Application for Licence Amendment

Licence Number	L9010/2016/1
Licence Holder	Mount Morgans WA Mining Pty Ltd
ACN	612 053 291
Application Number	APP-0030200
Premises	<p>Mt Morgans Gold Project</p> <p>Legal Description - Mining tenements: M39/236, M39/395, M39/390, M39/272, M39/18, M39/228, M39/264, M39/304, M39/240, M39/248, L39/246, M39/441, M39/250, M39/504, M39/745, M39/403, M39/282, M39/36 and M39/1107 LAVERTON WA</p> <p>As defined by the premises maps attached to the revised licence</p>
Date of Report	05/02/2026
Decision	Revised licence granted

Figure 1: SWL in monitoring bores from January 2023 to August 2025 (Sourced from Mount Morgan 2025)

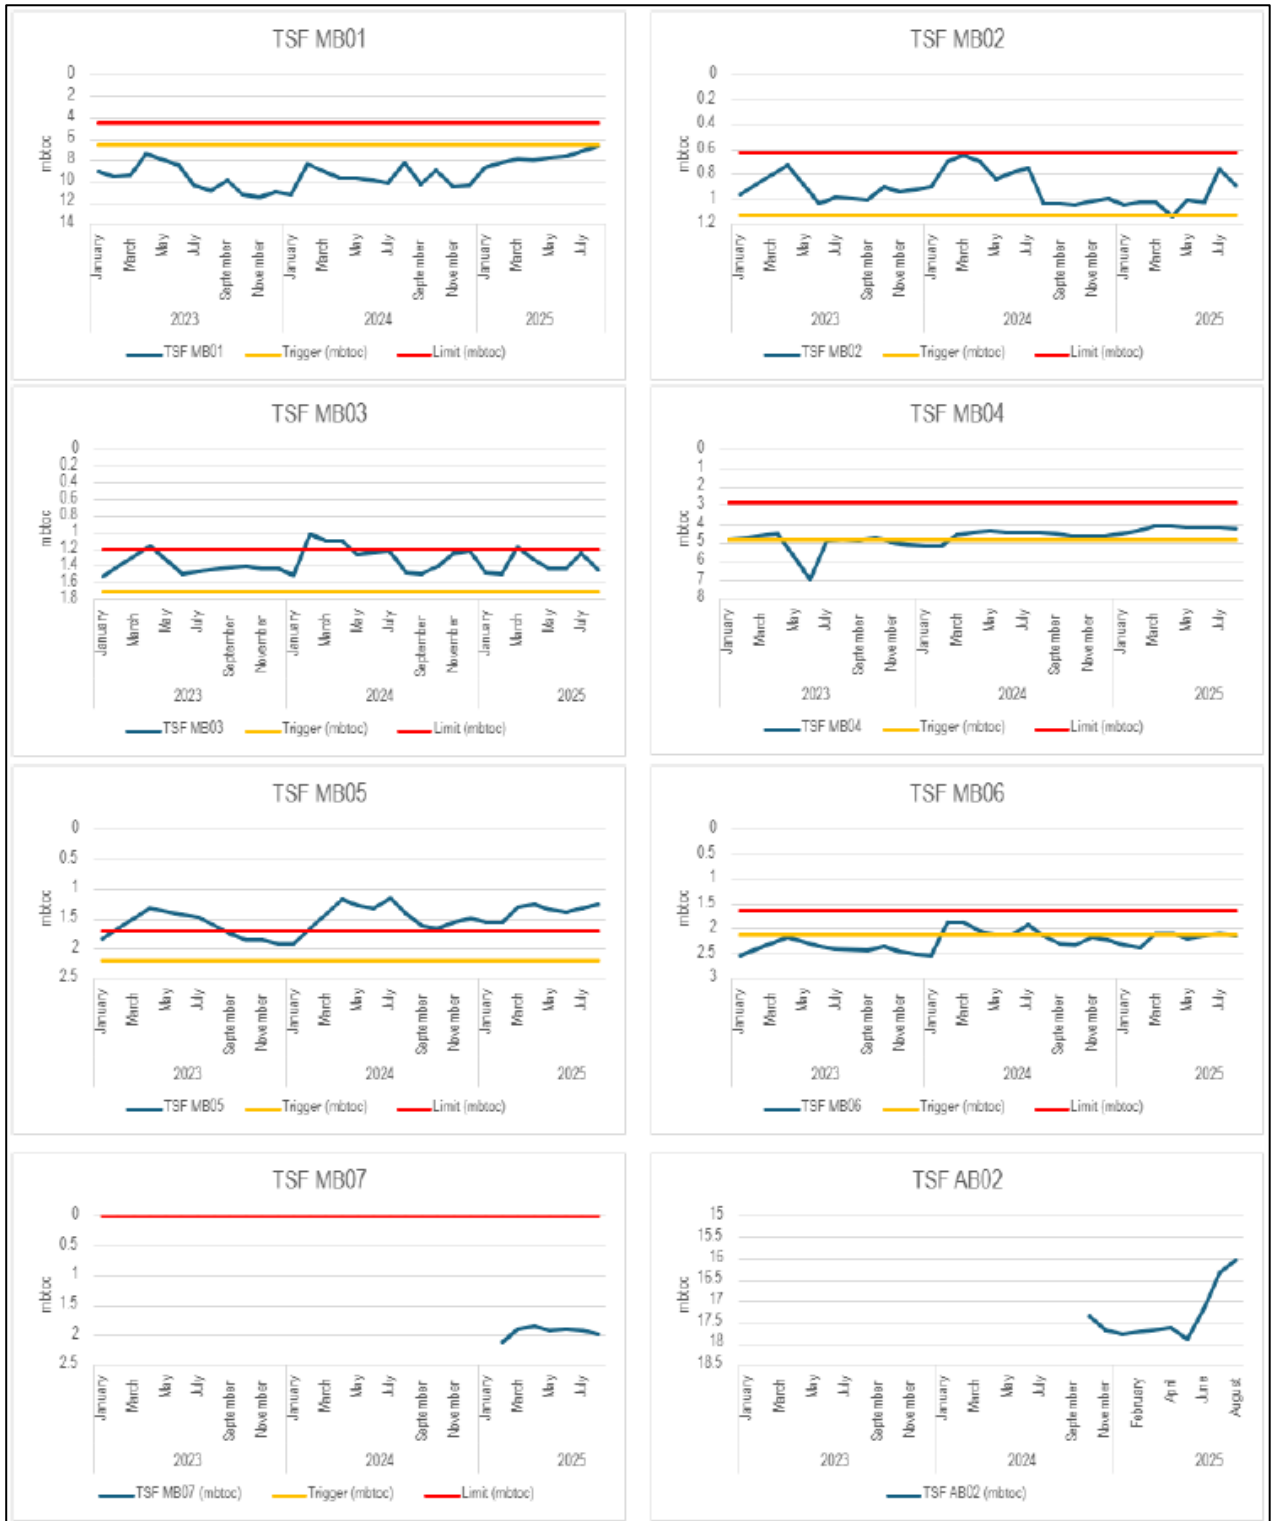
Groundwater SWLs around the TSF showed a slight increase in monitoring bores near Cell 1 (TSF MB1–TSF MB3) and a decline near Cell 2 (TSF MB4–TSF MB6) (Figure 1). The licence holder attributed these fluctuations to seasonal trends influenced by rainfall (Mount Morgan, 2025).

Figure 2: Monitoring bore, abstraction bore and seepage infrastructure locations (Sourced from Astill 2025)

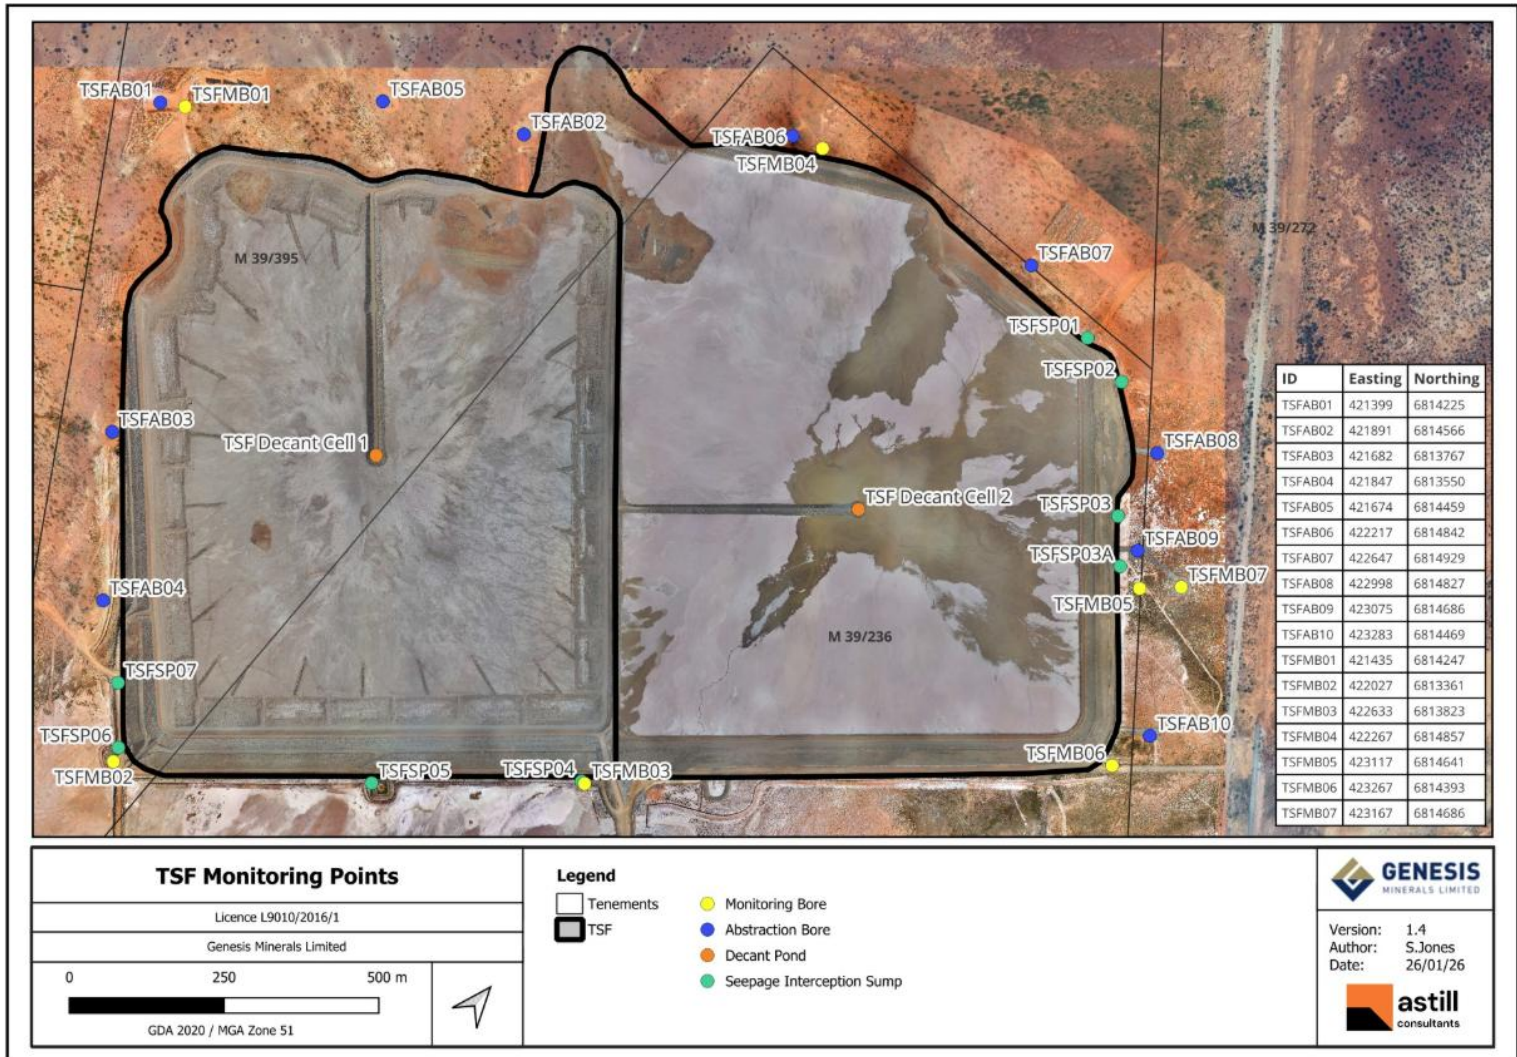
The licence holder has proposed to continue annual vegetation monitoring in accordance with existing condition 1.2.6 (see below). Seepage and mounding from the TSF is managed through a variety of seepage recovery infrastructure (figure 2) involving recovery bores, seepage interception trenches and sumps. The seepage recovered is either returned to the TSF or is used in processing.

Figure 3: TSF MB05 SWL

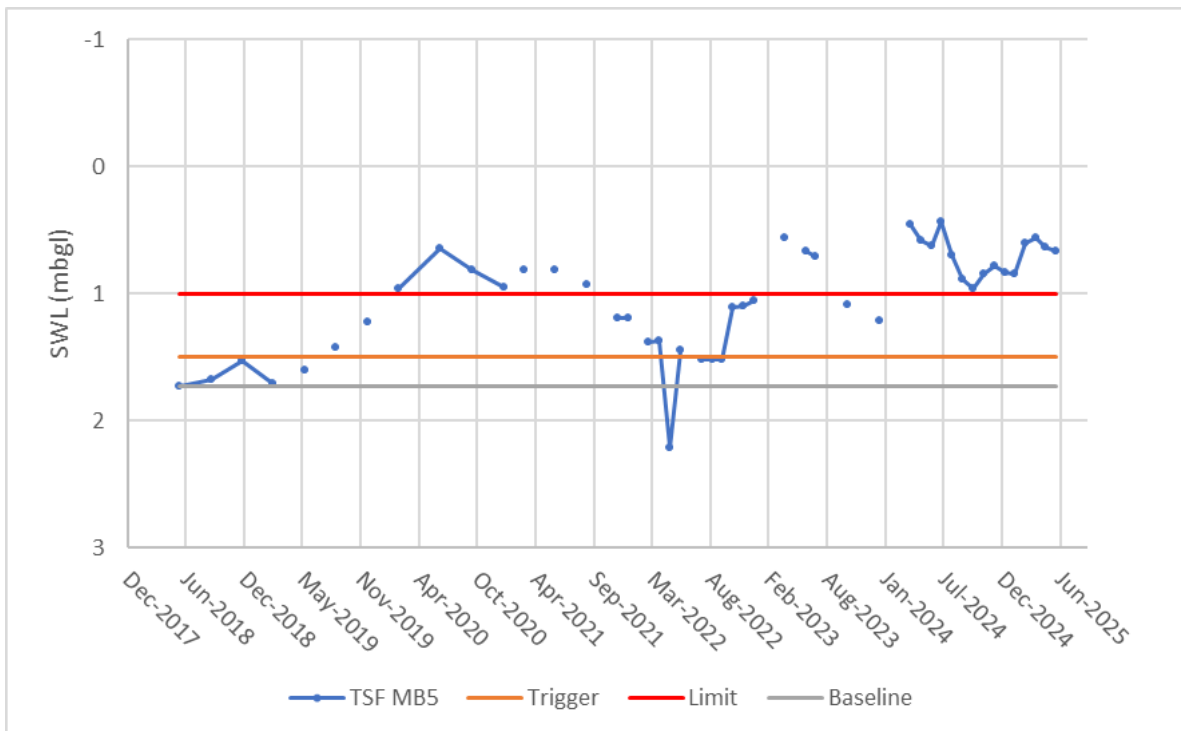
TSF MB05 was installed in June 2018, with a recorded baseline SWL of 1.73 mbgl.

Since commencement of TSF operations, groundwater levels within TSF MB05 have risen from 1.73 mbgl to approximately 0.6–0.8 mbgl (Figure 3).

The primary risk to receptors in the area, particularly native vegetation, is associated with rising groundwater caused by mounding, which is attributed to seepage from the TSF and increase in pressure on groundwater levels due to tailings deposition.

Based on the information outlined in the preceding sections, the department has determined that removing the SWL limit /trigger for bore TSF MB05 is acceptable, provided it is replaced with a nearby monitoring bore that includes an appropriate limit and trigger value to ensure groundwater levels are maintained at an acceptable level in the NE quadrant of the TSF for the prevention of impacts to native vegetation.

During the 21-day comment period the Licence Holder suggested monitoring bore TSF MB07 as a suitable replacement bore as it will be more representative of groundwater levels that could impact native vegetation due to its location. The department has determined that TSF MB07 is an appropriate replacement bore and has applied a trigger of 1.5 mbgl and a limit of 1 mbgl to bore TSF MB07. The department considers the new triggers and limits for TSF MB07 are suitable to prevent future impacts to vegetation in the NE quadrant of the TSF. Condition 3.5.2 requires the licence holder to implement groundwater recovery if SWL triggers are exceeded.

Figure 5: NDVI long term trend TSF Area (Top) Baseline Vegetation (Bottom) Sourced from RPM 2025).

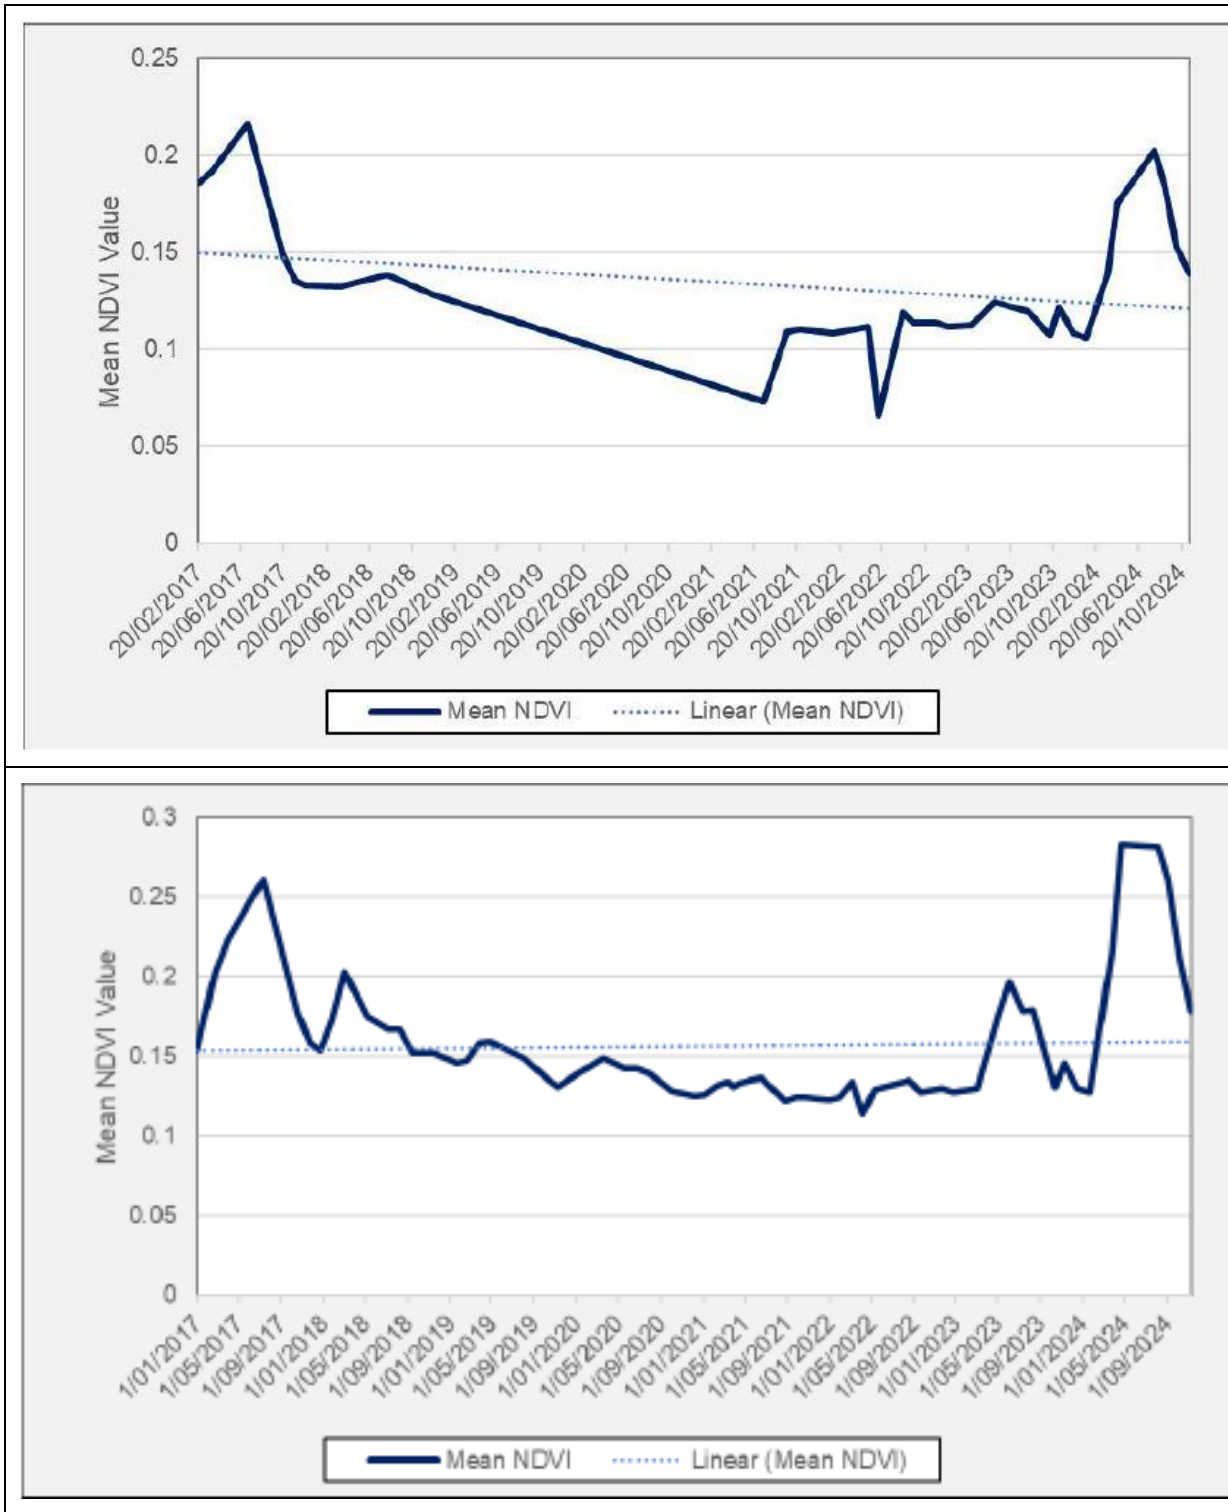
NDVI monitoring results indicate a historical decline in vegetation within the TSF area (Figure

5). When compared to baseline vegetation data, this decline appears to be widespread across the region however, suggesting it is largely unrelated to TSF influence. Analysis of historical rainfall patterns alongside NDVI trends indicates that vegetation loss is primarily driven by an overall reduction in rainfall rather than site-specific impacts.

Figure 7: Historical aerial imagery of vegetation northeast of the TSF taken on 7 November 2024 (Sourced from Nearmaps 2025).

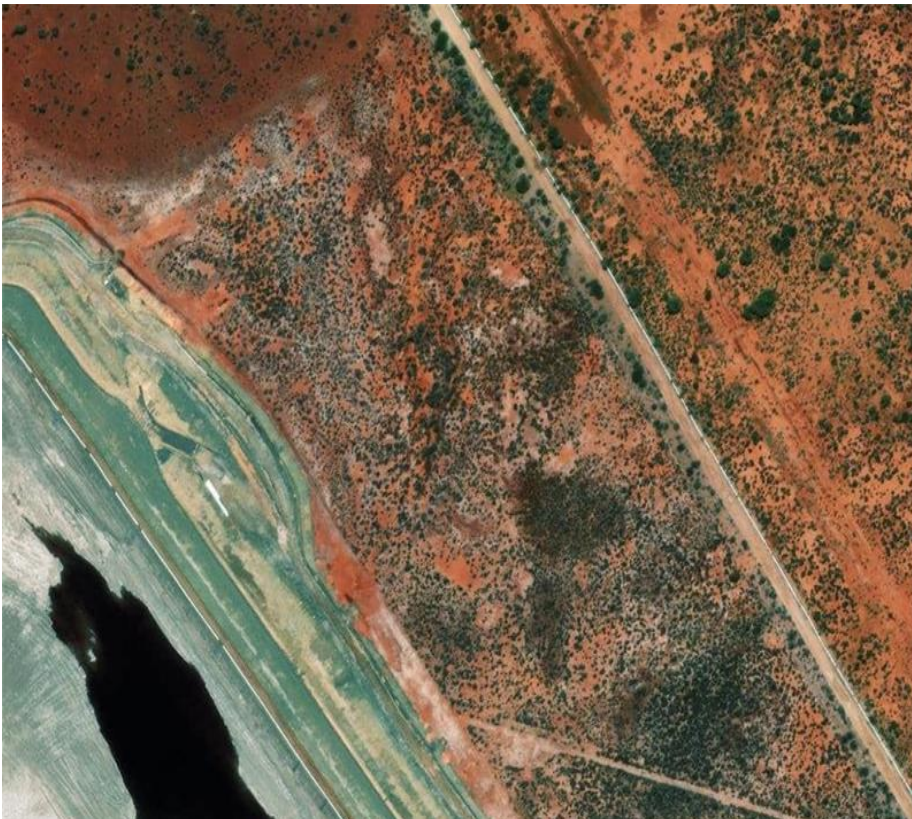
On 24 September 2020 the licence holder notified the department of native vegetation loss associated with the TSF. Approximately 3.8 hectares of native vegetation on the eastern side of the TSF were impacted by salt deposits from receding surface water. Since 2020 additional salt accumulation appears to have occurred within the area and near TSF MB05 as presented in Figure 6, Figure 7 and within photographs taken during the vegetation monitoring events (Figure 8).

Figure 8: Photographs of NE quadrant during annual vegetation monitoring (Sourced from RPM 2022 and RPM 2025)

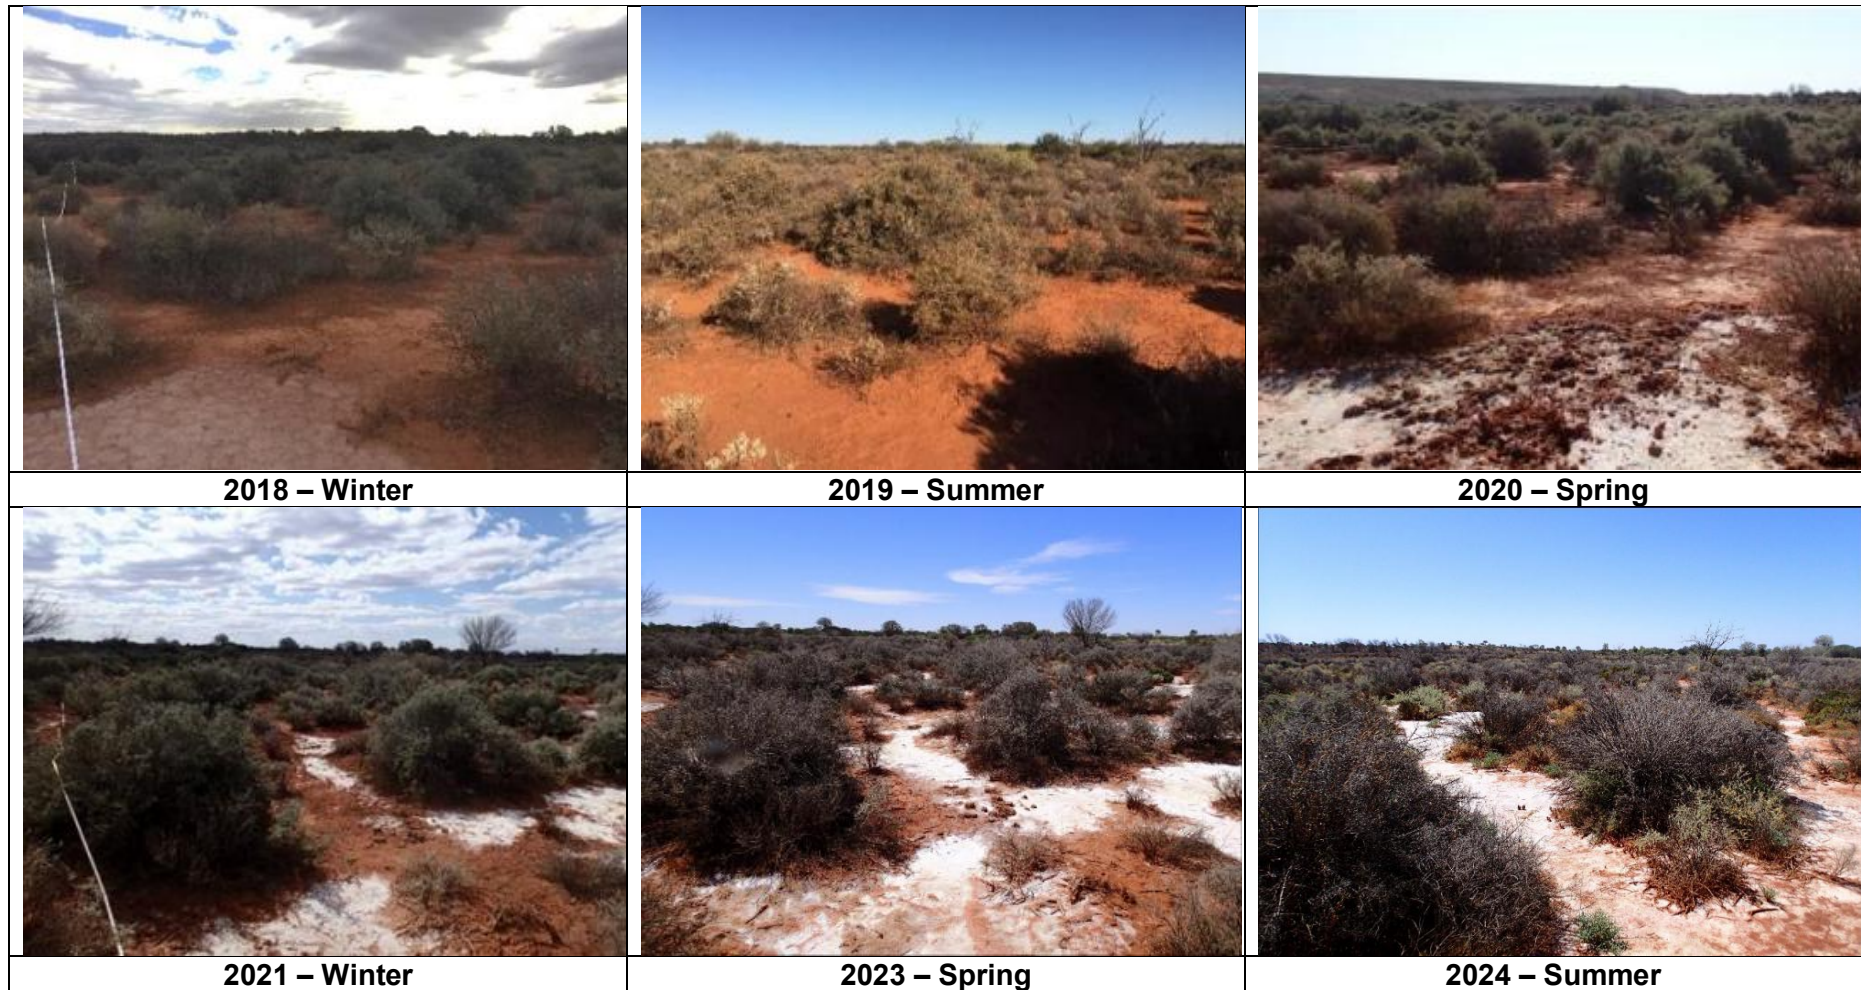
The Licence Holder’s historical vegetation monitoring results and reports state that the TSF is not attributing to any vegetation loss, however, the department notes that vegetation loss has been experienced at monitoring location Q NE near monitoring bore TSF MB05. The department considers that the vegetation cover reduction (Table 6), the increase in soil salinisation (Figure 8) and rising groundwater levels are possibly contributing to the decline and may be attributed to the TSF operation.
